Nonconformance Report

**Solar Orbiter
Energetic Particles
Detector (EPD)**
EPT-HET ☒ STEP ☐

NCR Title **SO-EPD-KIE-NC-0016 post Vib FT anomalies**

Model . **PQM**

Abb 1 Assembly top

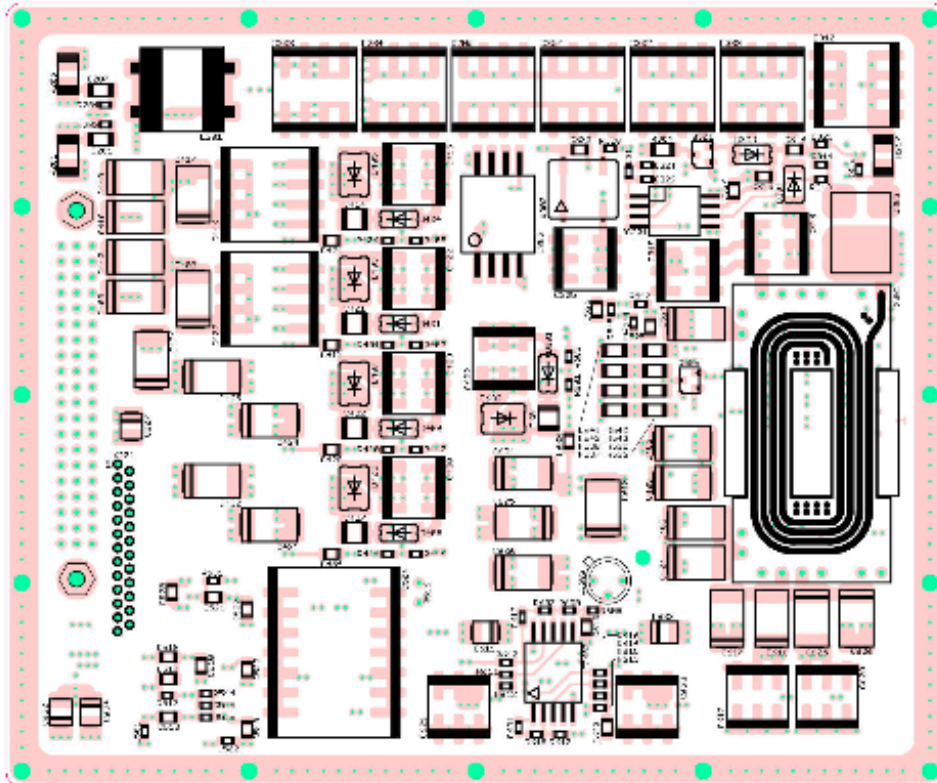
The LVPS has multiple cracks in pins of different parts. Two cracked pins of the PWM generator seems to be the reasons for the falling analog voltage during vibration.

One of the two cracked pins is the feedback input for PWM generator.

Analog PQM Board

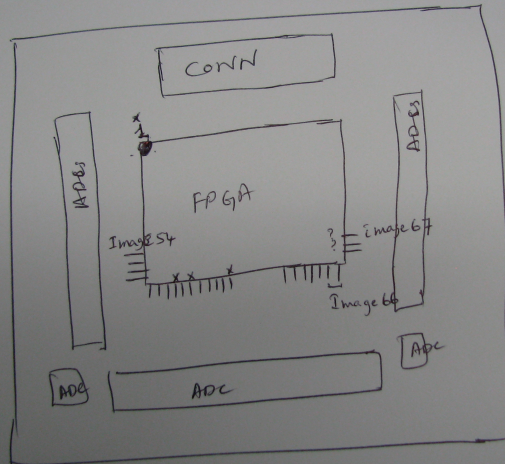
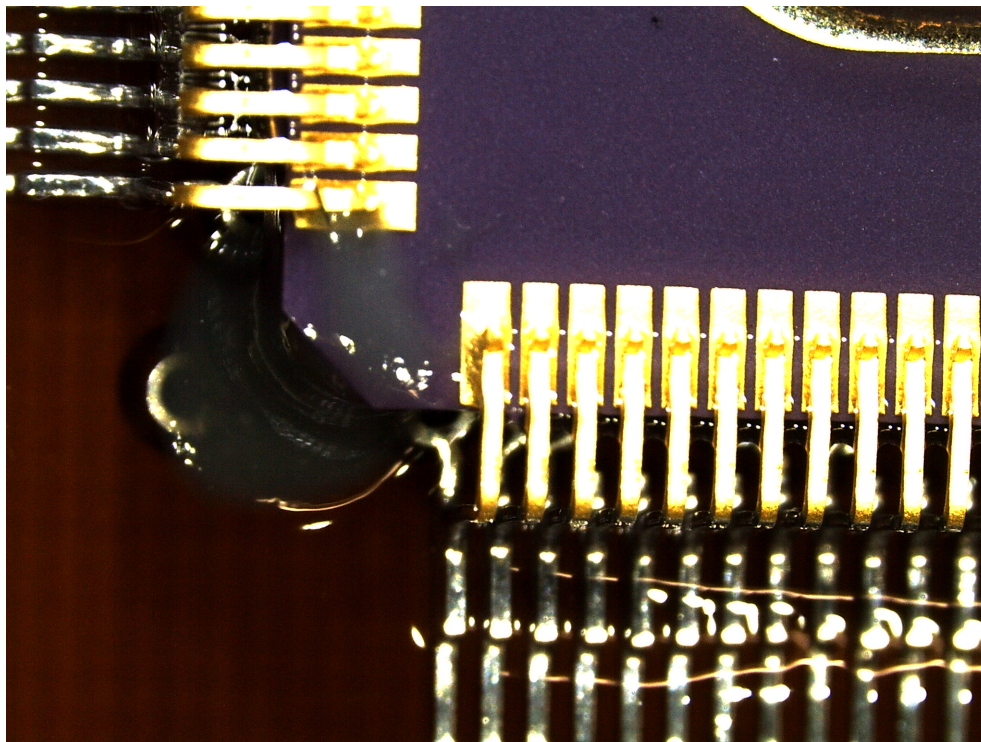
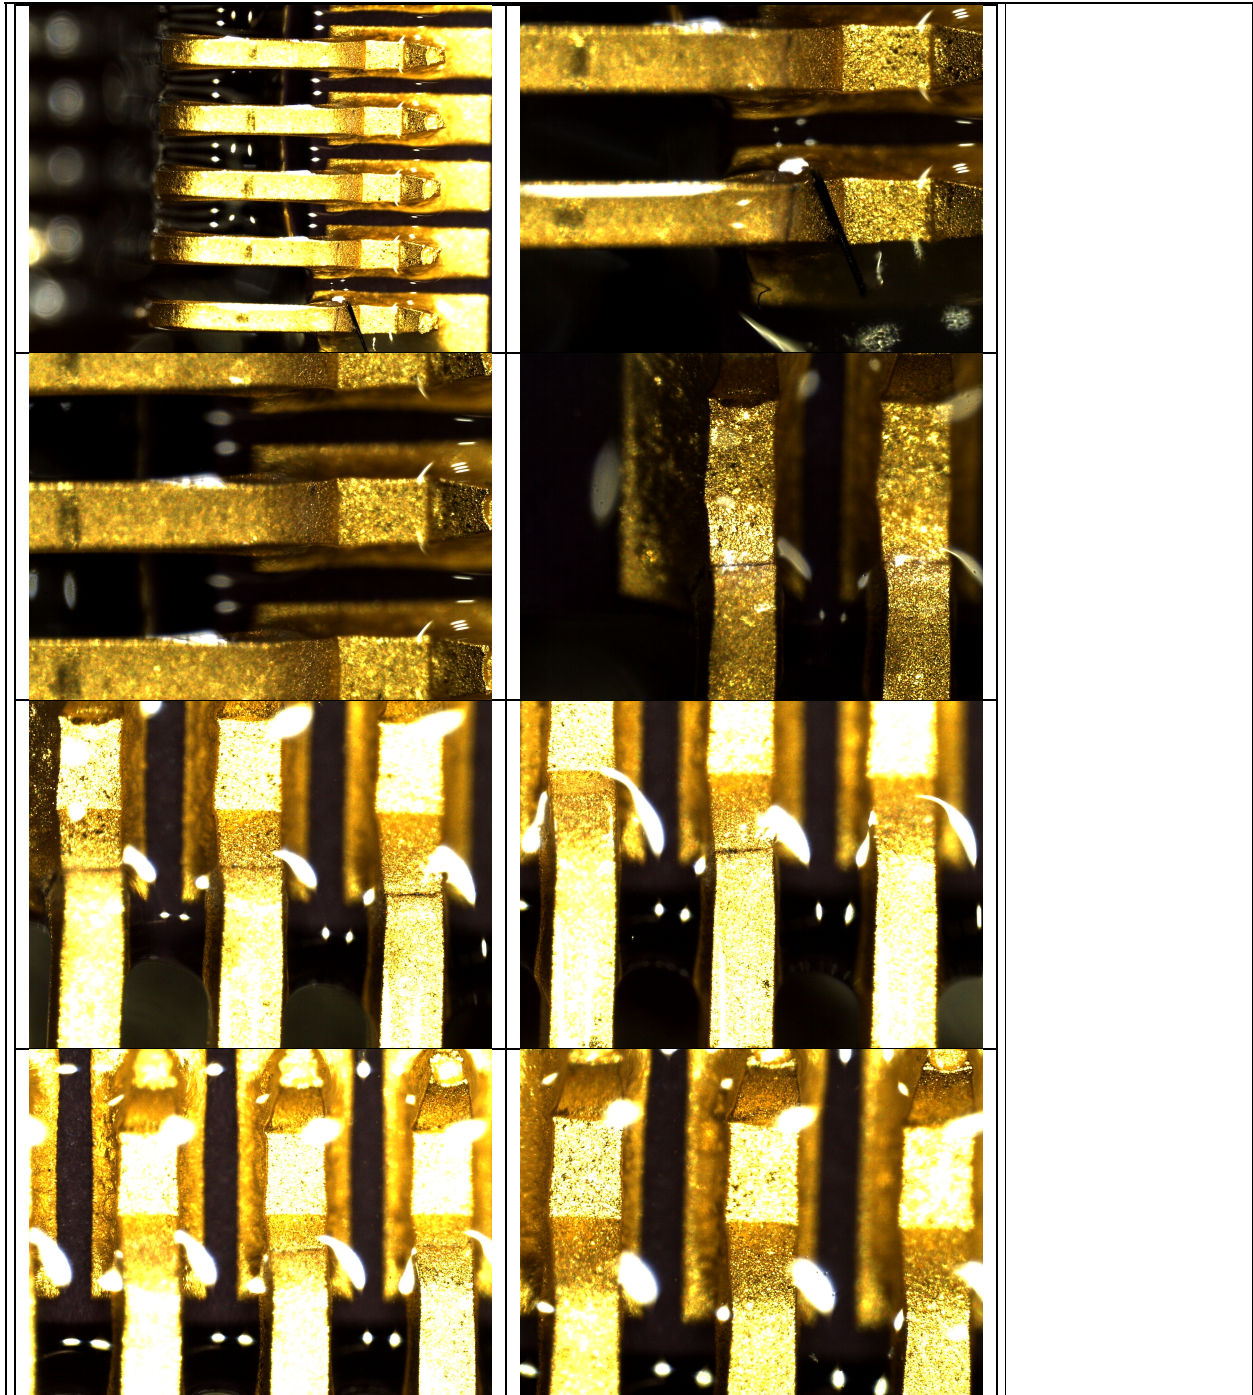
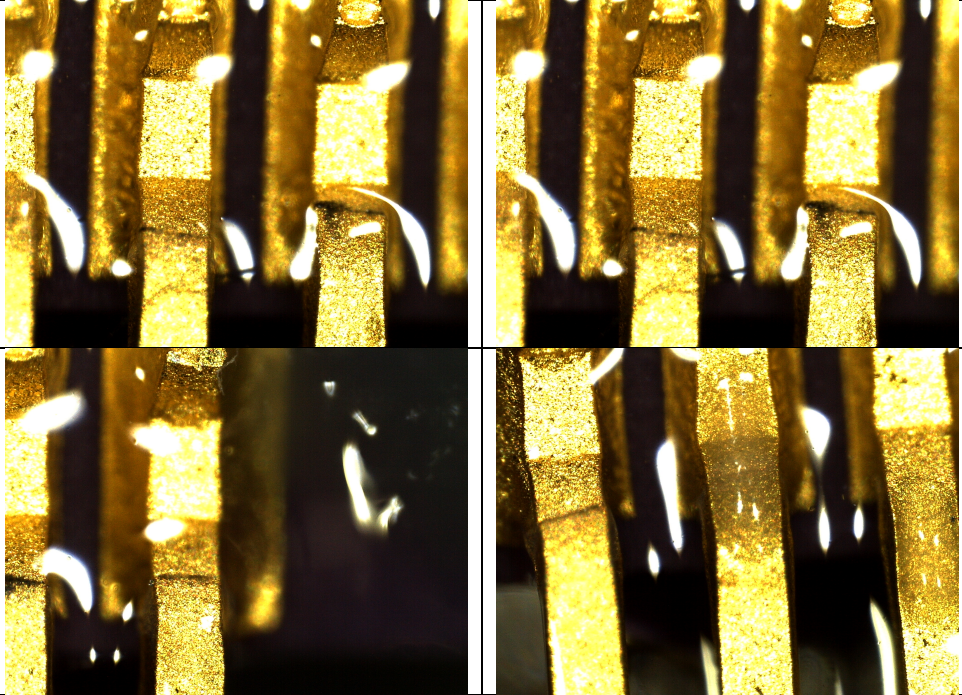
(2) On 2015-05-28 Shri Kulkarni posted his investigation of the Analog board. Cracks were observed in FPGA legs, as indicated in the sketched assembly diagram, and documented by photos.

Digital and Analog board FPGAs – the issue is, the FPGA is not adequately supported by the mechanical frame; this is worst for the Analog board where the FPGA is in the center of the board.

Bending of the boards under vibration is the cause of the FPGA broken legs; stiffening the boards by using thicker pcb would help, and improving the fixation of the boards to the frame would help.

For testing STEP, notching during vibration would avoid the same problem with FPGAs.
